Subject: Exelon Nuclear Texas Holdings, LLC
Victoria County Station
Early Site Permit Application
Environmental Report – Response to ER RAI Letter No.5
Docket No. 52-042

- ESP EIS 9.3.1-1 (eRAI No.6394)

ESP EIS 9.3.1-1 (eRAI No.6394, RAI Letter No. 5):**NRC Request:****ESP EIS 9.3.1-1**

Figure 1 ERCOT Map with Depiction of Adequate Water Areas

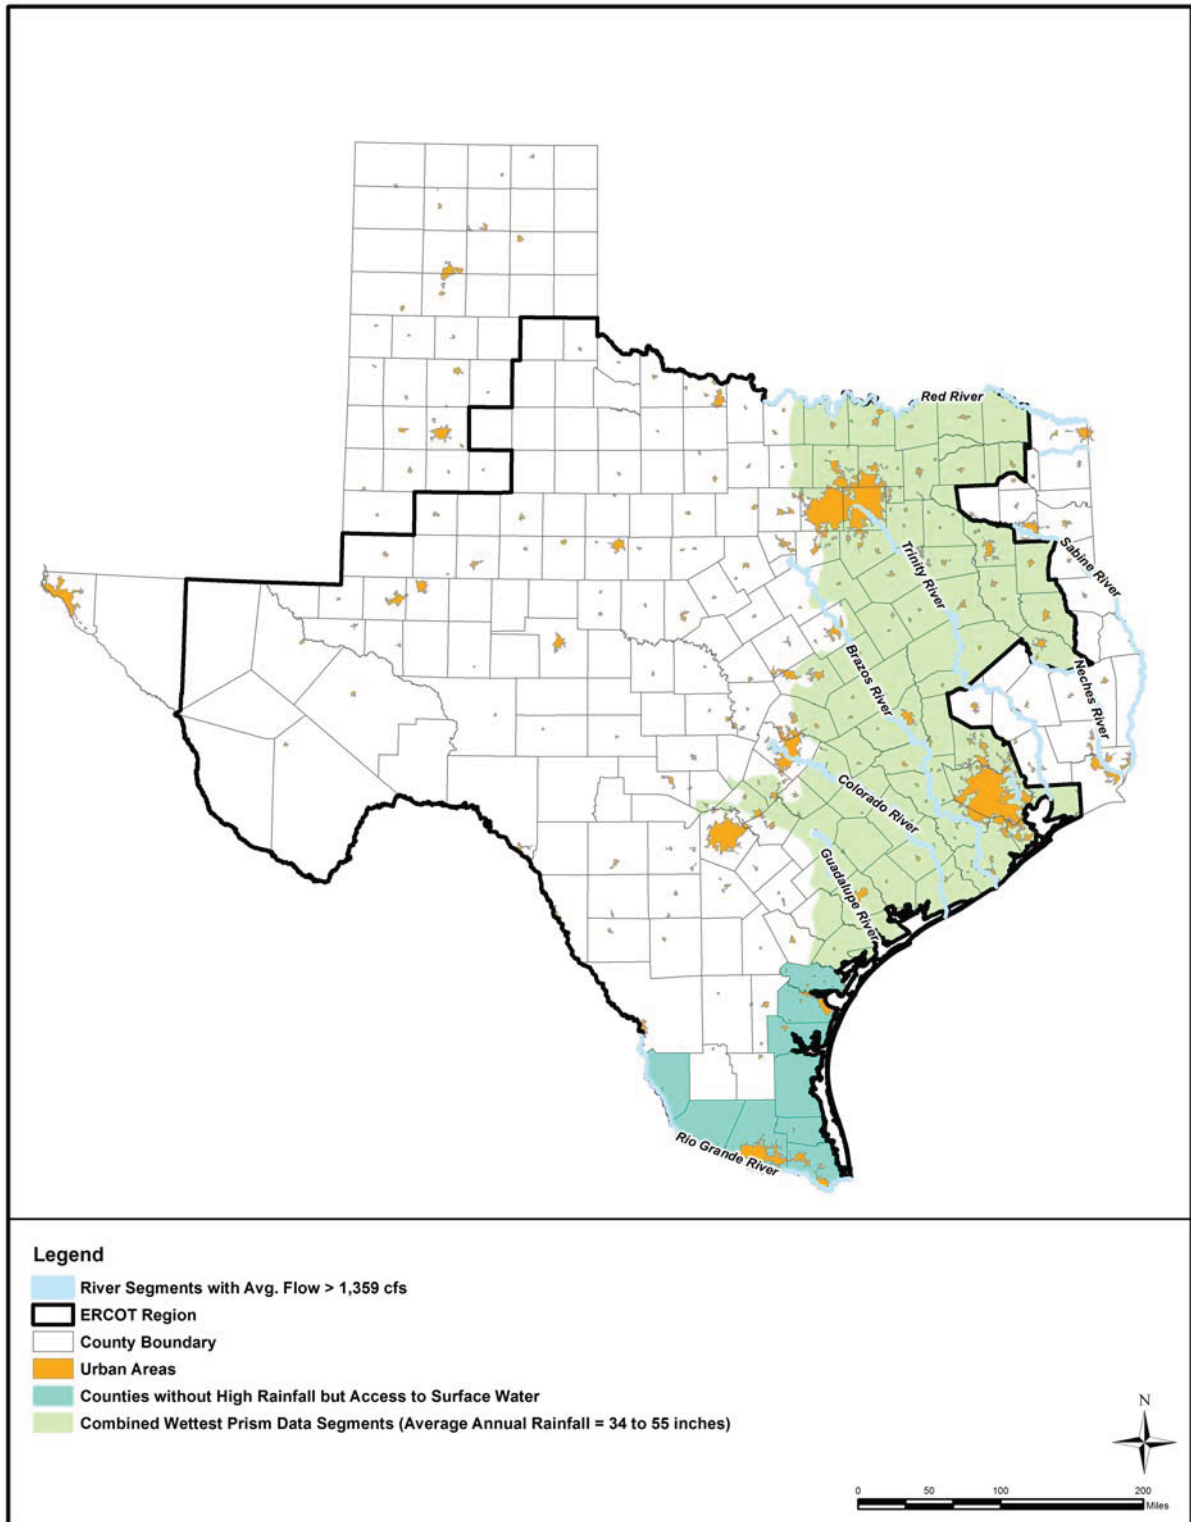
The ESRP Section 9.3 requires NRC to review the process by which the applicant has identified and evaluated alternative sites for the proposed action. Details of the applicant's site selection methodology must be available to support the NRC's evaluation of its reasonableness and to make sure that there is no other site that is obviously superior to the one being proposed by the applicant. This requires an analysis of alternative sites to support the determination of whether there is an obviously superior site in terms of overall environmental impacts and costs when compared to the site proposed by the applicant. Selection of candidate areas was separate from identifying and evaluating candidate sites and sufficient details of the decision-making process were not provided in the ER. Provide a discussion regarding the manner in which the candidate areas in the site selection process for the alternative sites were identified. Include all of the factors that influenced these selections and the values assigned to each criterion.

To verify that the “adequate water area” selected using the PRISM data was consistent with the site selection estimate of 61,000 gpm (135.9 cfs), Exelon analyzed surface water flow characteristics for major rivers in Texas using GIS data compiled by the U.S. Geological Survey (USGS 2003). Specifically, USGS gaging stations with an average daily stream flow greater than 10 times the estimated maximum consumption rate for the project (or average flow greater than 1,359 cfs) were identified. Applying a flow rate of 10 times the project requirement resulted in identifying river segments that have the physical availability of water to supply the new facility and a reasonable potential to acquire the necessary cooling water supplies. The gaging station most upstream on each major river meeting the flow requirement was identified as the point below which the river possesses sufficient flow to be identified as a viable cooling water source. The major rivers were then split into two segments at these locations: the upstream segment not meeting the flow requirement, and the downstream segment meeting the flow requirement. The river segments meeting the flow requirement are depicted in Figure 1, along with the adequate water area defined using the PRISM data.

Figure 1 indicates good correlation between the major river segments with sufficient flow and the wettest areas from the PRISM dataset, confirming the selection of the adequate water area. Figure 1 also shows that the lower portion of the Rio Grande River basin appears to have adequate physical water availability to support a new nuclear facility. Despite low average annual precipitation in the southern portion of Texas, the large size of the Rio Grande River watershed (approximately 176,000 square miles of contributing area) results in the observed average flow rates (RGRWPG 2006). Accordingly, counties in the lower Rio Grande basin were retained for further consideration.

Coastal counties not already within the adequate water area determined from the PRISM data were also examined as potential sites for saltwater cooled plants (see Figure 1).

Figure 9.3-2a. Counties Remaining After Application of Exclusion Criteria

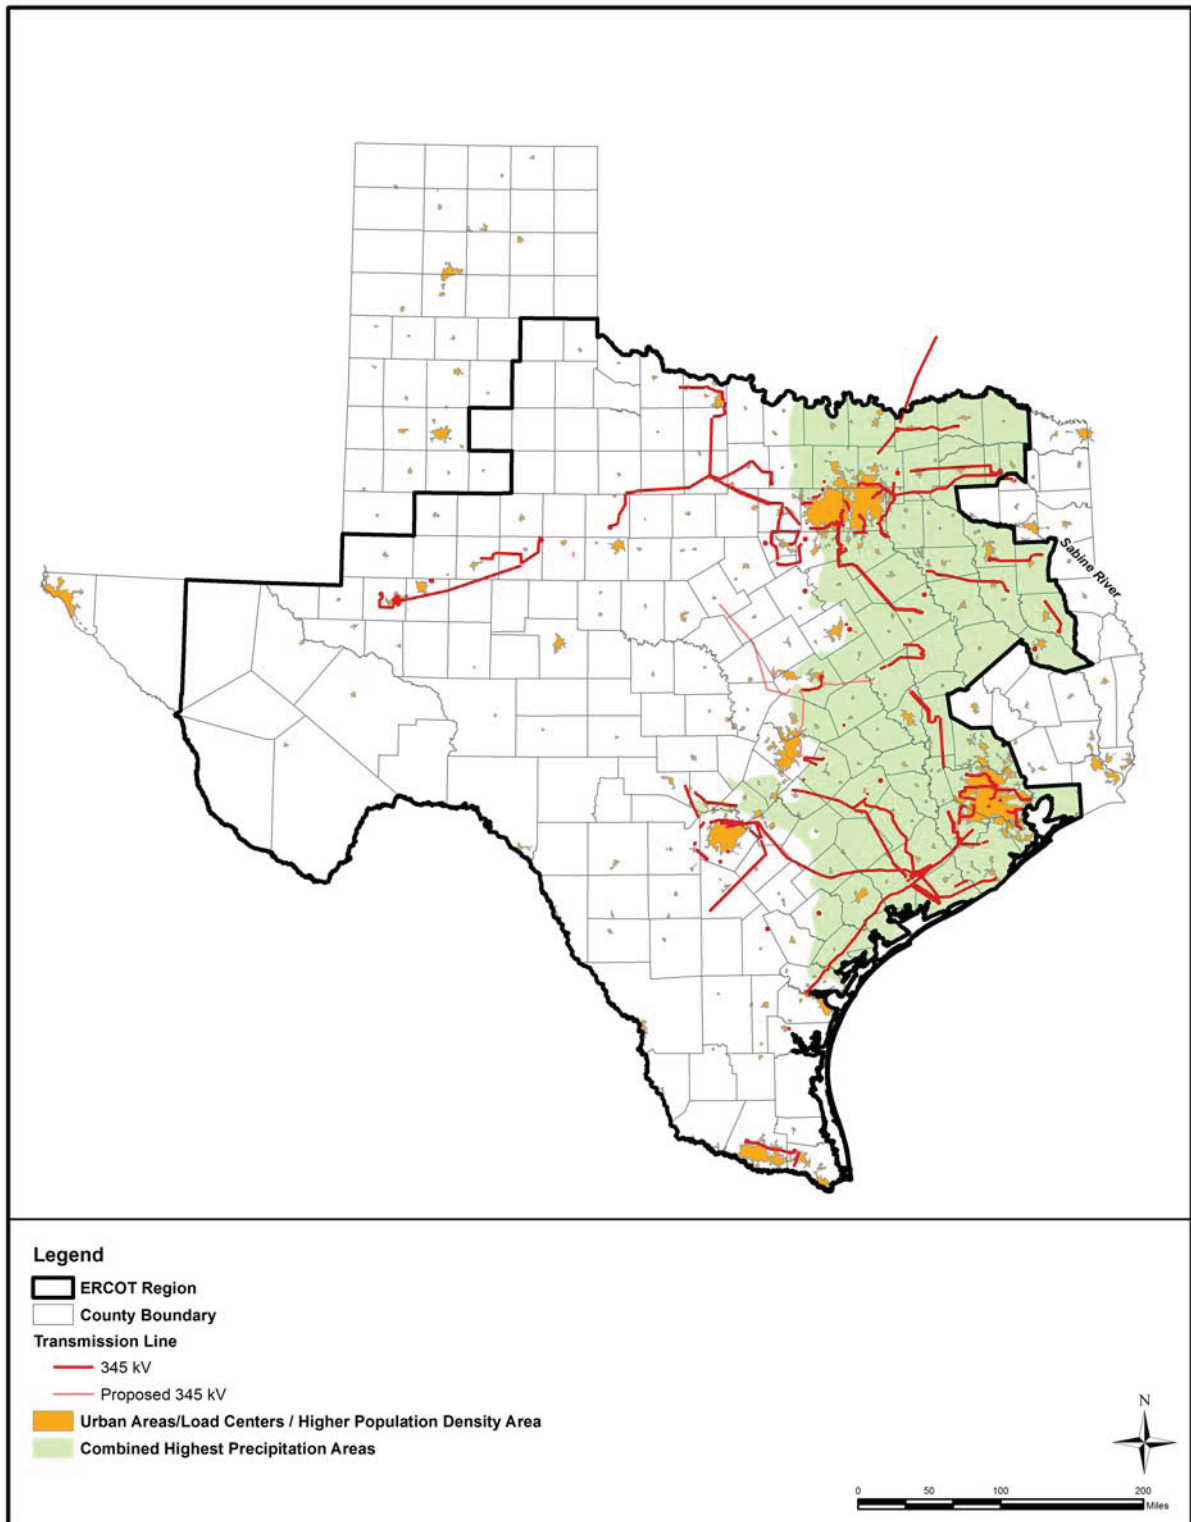
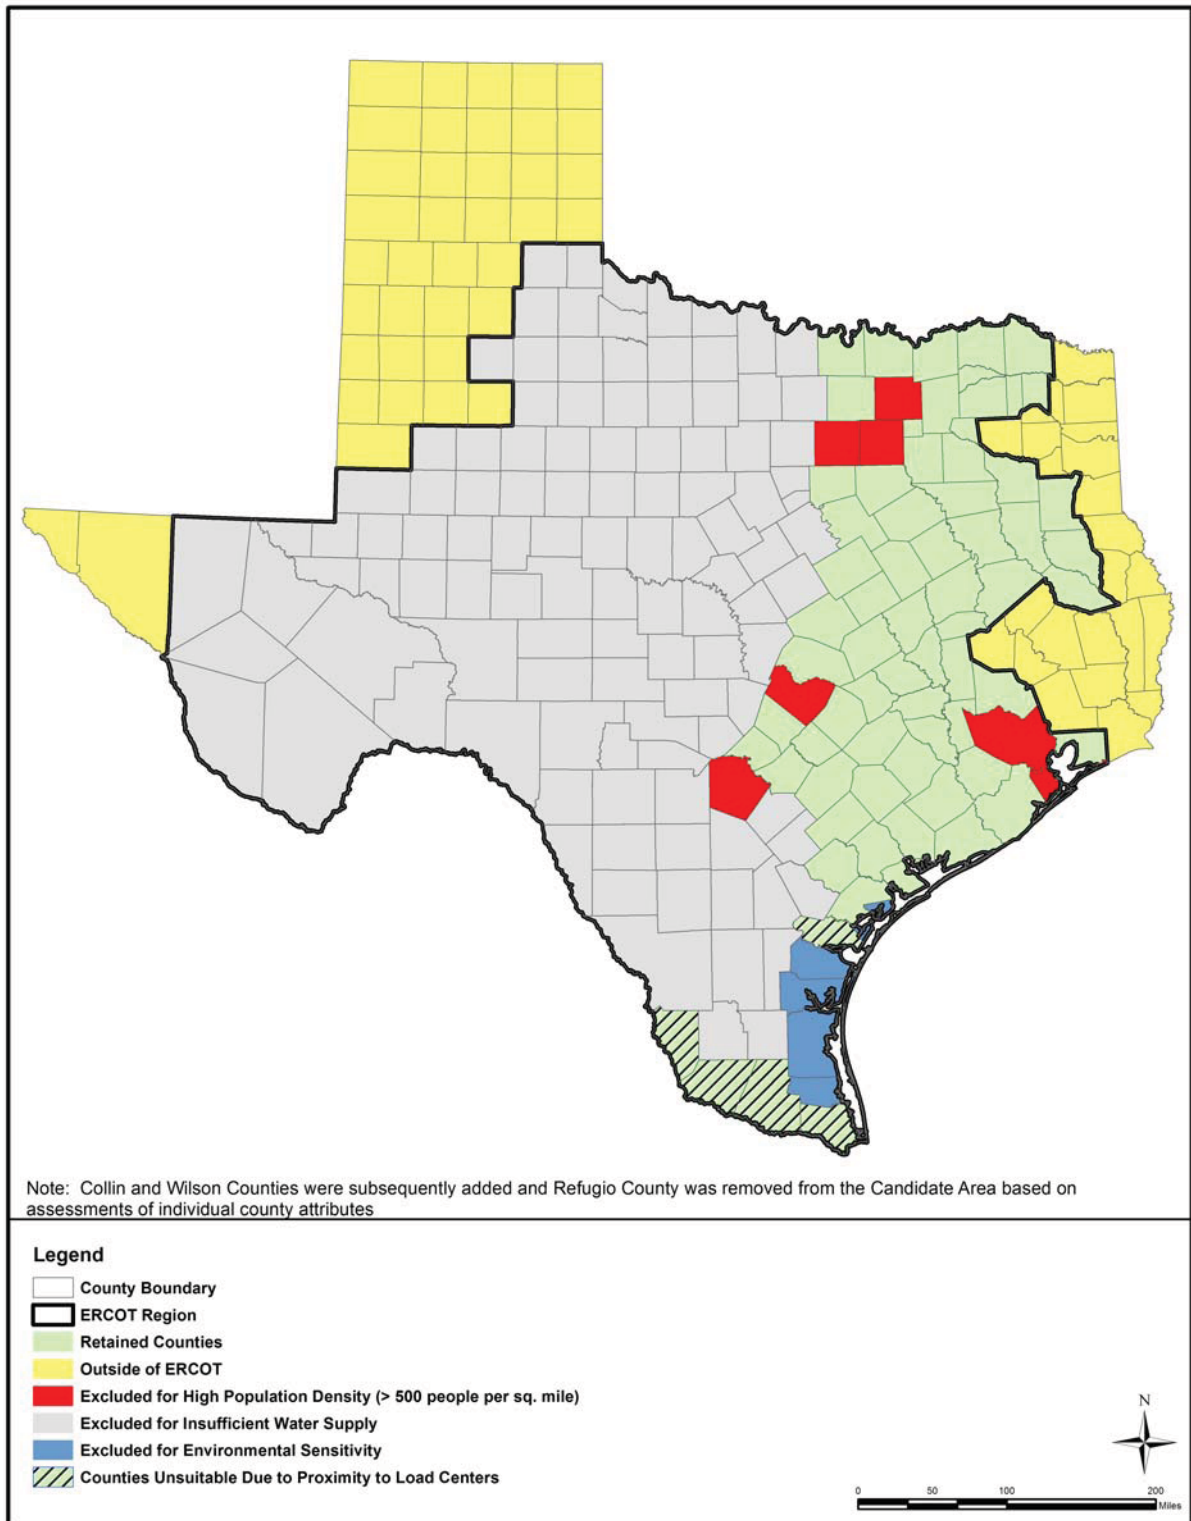
Figures 9.3-2 and 9.3-3 will be replaced with Figures 9.3-2a, 9.3-2b, and 9.3-3 in a future revision as indicated below.

9.3-2a and 9.3-2b summarize the application of exclusionary and suitability criteria during Candidate Area selection. Figure 9.3-3 presents the Candidate Area counties.
